## COMMENTS FILED IN AM DIRECTIONAL ANTENNA PROCEEDING

On May 4 of this year a coalition of broadcasters, broadcast consulting engineers and equipment manufacturers submitted to the FCC draft modifications to existing rules and proposed new rules that would permit the use of computer modeling to proof and maintain AM directional antenna arrays (see the [May 14, 2007 issue](#) of *Radio TechCheck* for additional information). Subsequently, on May 23, 2007 the FCC issued a Public Notice (available on the FCC Web site at [http://hraunfoss.fcc.gov/edocs\\_public/attachmatch/DA-07-2143A1.pdf](http://hraunfoss.fcc.gov/edocs_public/attachmatch/DA-07-2143A1.pdf)) requesting comment on this proposal.

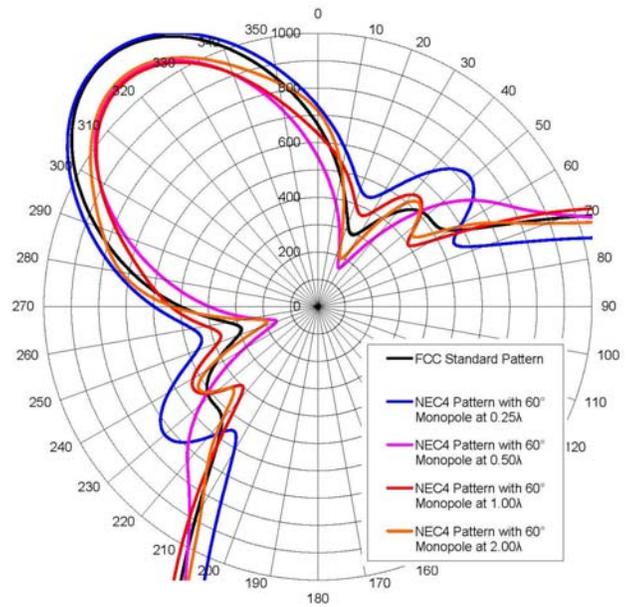
To demonstrate this, AFCCE included several examples of modeling results (using NEC-4). The first polar plot shown here illustrates the predicted impact of a monopole tower (added to a four-tower array model) having a height of 60 electrical degrees (the proposed height threshold for the non-directional case). The predicted impact on the directional pattern is shown for monopole locations ranging from 0.25 wavelengths to 2 wavelengths from the end tower of the array. Based on this example, a 60 degree grounded monopole located in close proximity to a typical AM directional pattern could result in substantial distortion of the directional pattern particularly in the null regions of the pattern.

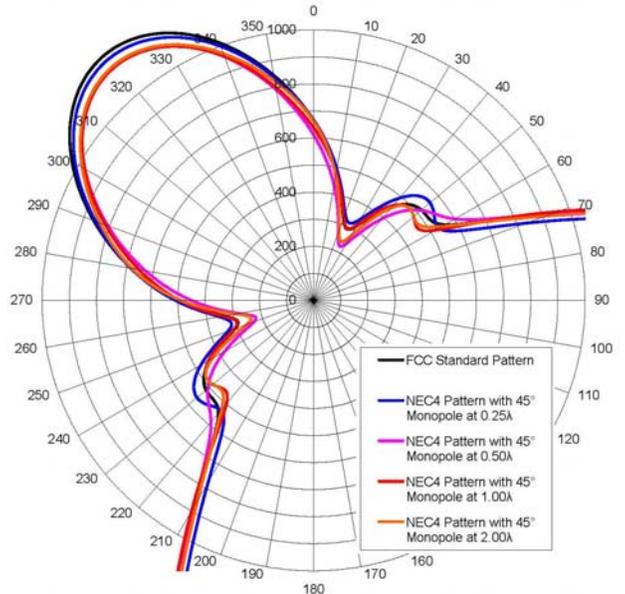
The second plot is similar to the first except in this case the monopole tower height is 45 electrical degrees. AFCCE believes that these plots (along with an additional plot for a monopole with a height of 36 electrical degrees, not shown here) illustrate that the proposed height threshold of 45 degrees would protect the vast majority of AM directional stations while accomplishing the goal of reducing burden on Commission staff and other FCC licensees.
